## MEMORANDUM – ADDENDUM NO. 1

**To:** Interested Vendors  
**From:** Cindy Clack  
**Date:** 12/15/2025  
**Re:** RFB2026-10 Covered Bridge Road Water Main Extension -- Addendum No 1

**PROJECT TITLE: Covered Bridge Road Water Main Extension, RFB2026-10**

E-2

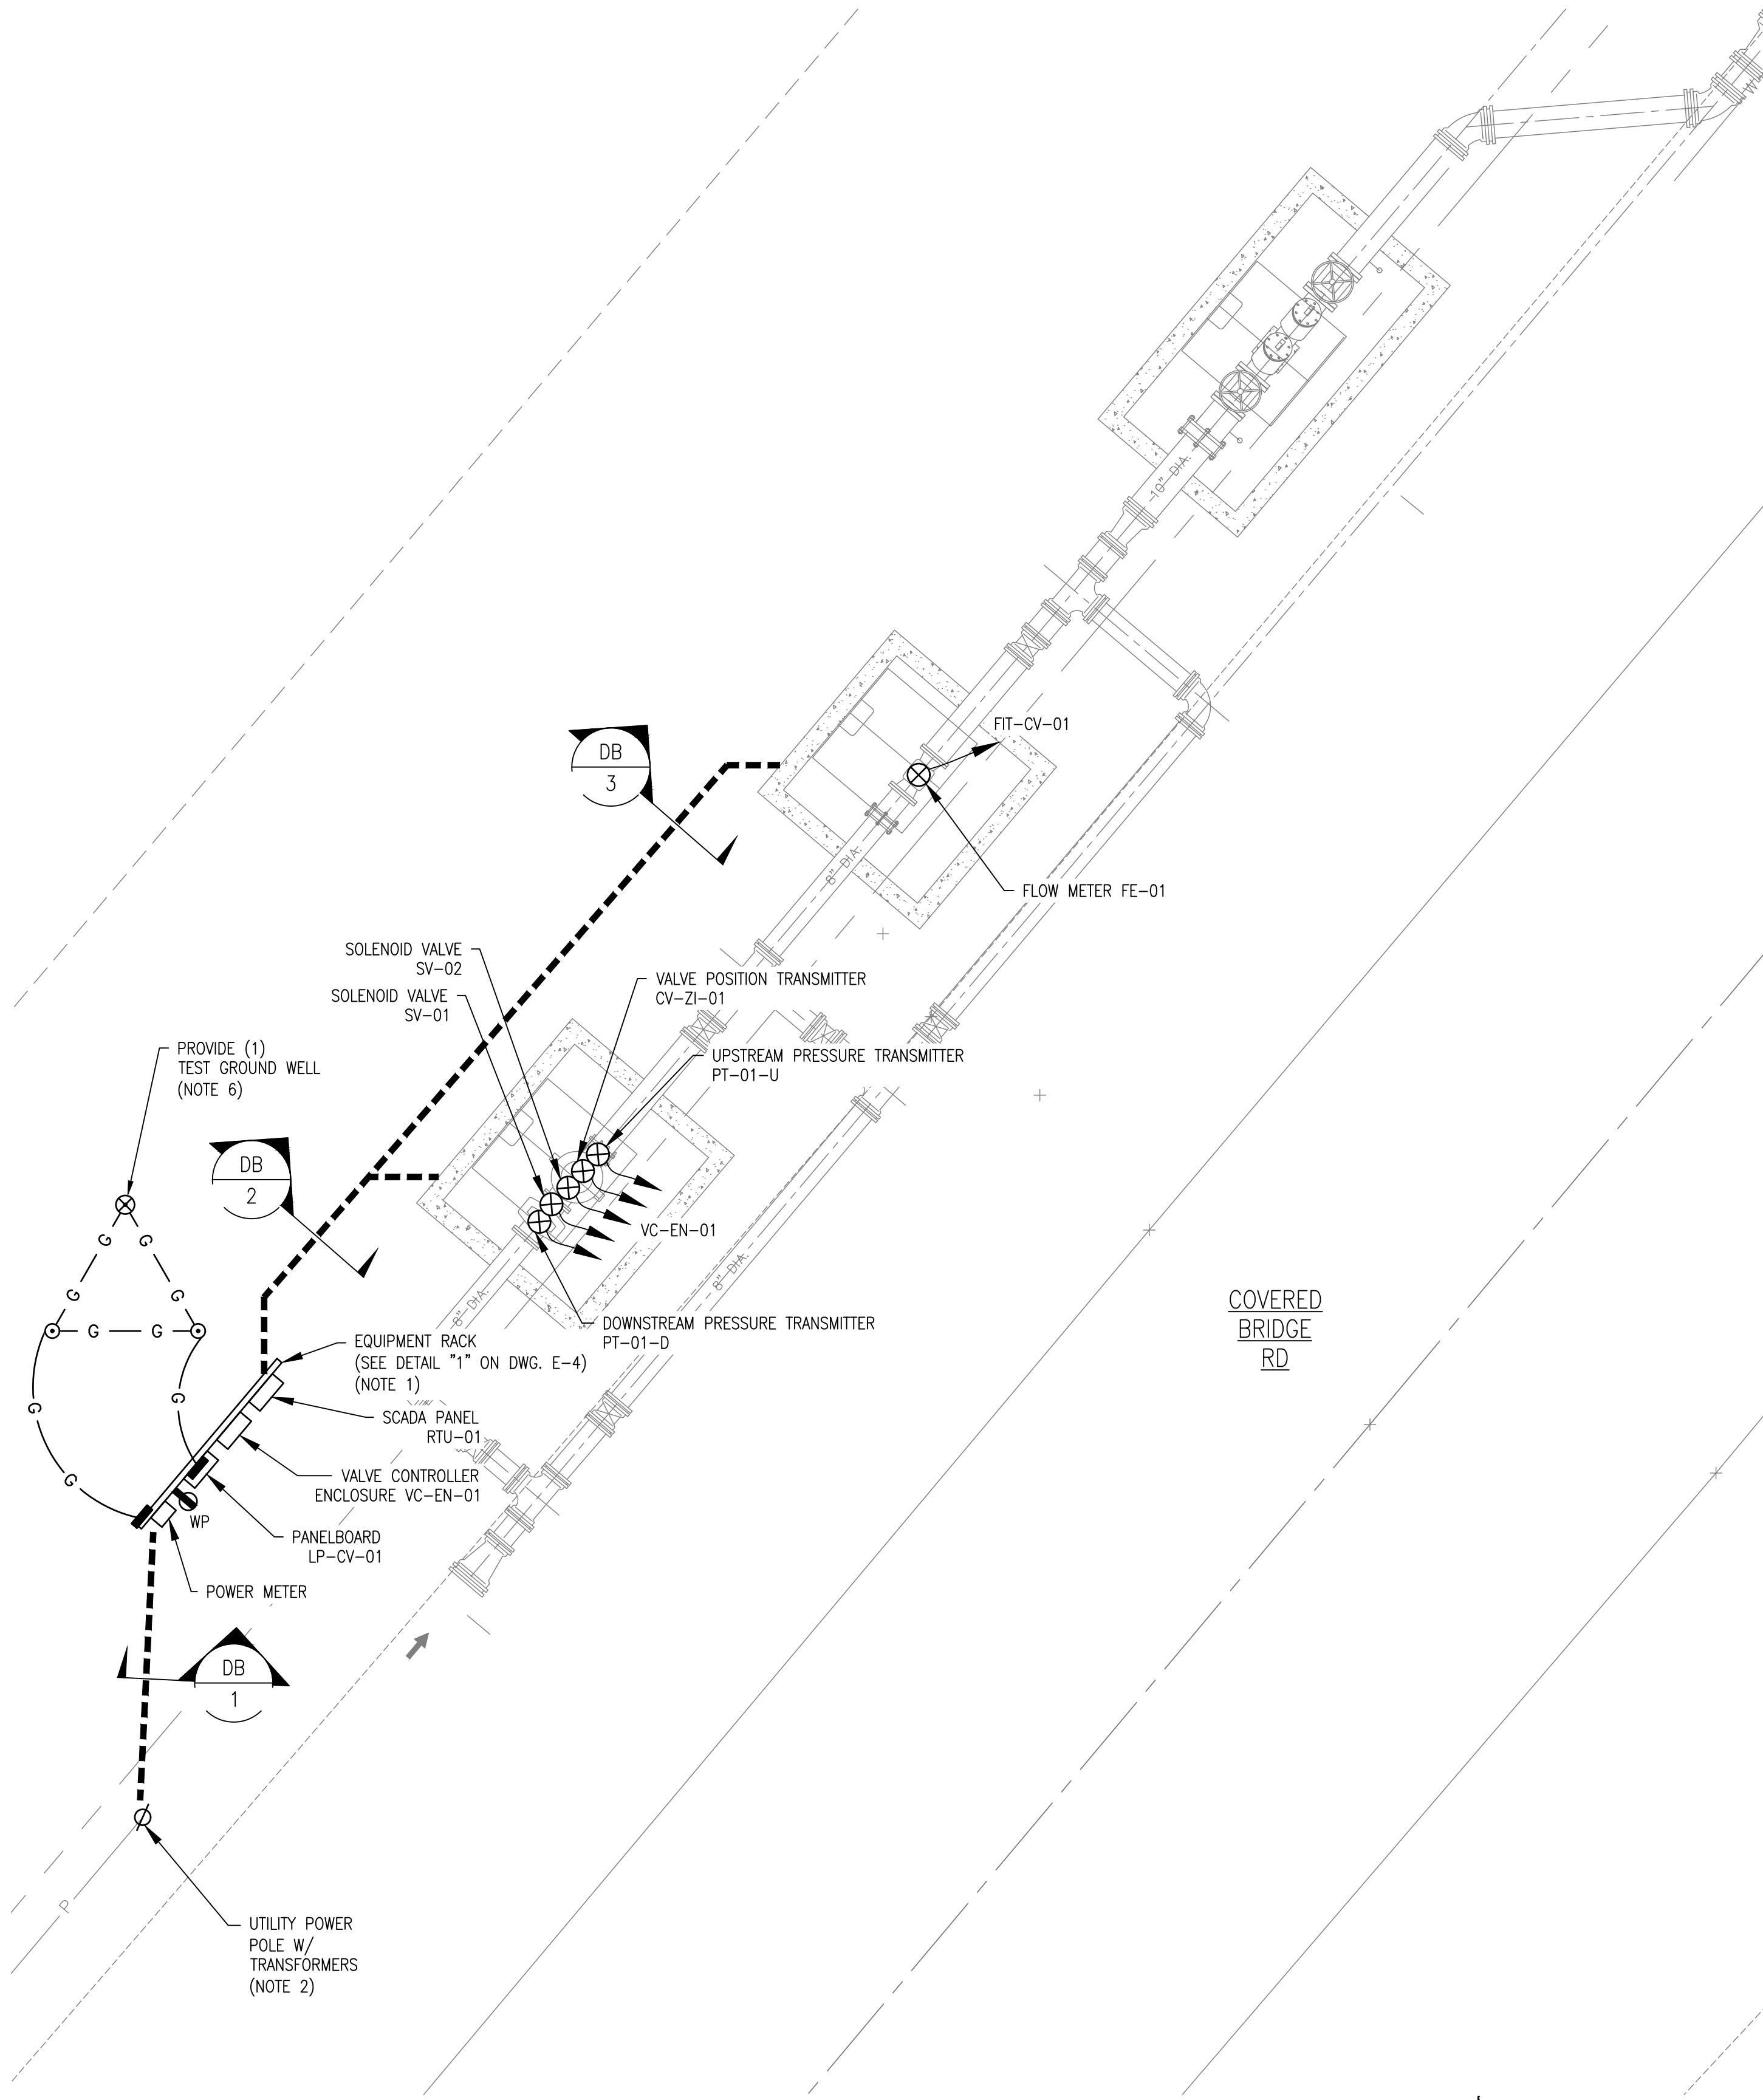
- Q5. *Clarification on system intergrader SCAD antenna installation requirements, per note #9 on sheet E-2 of construction plans.***
- A5. There will be no contractor requirements for antenna mounting, as it is included with the SCADA enclosure.
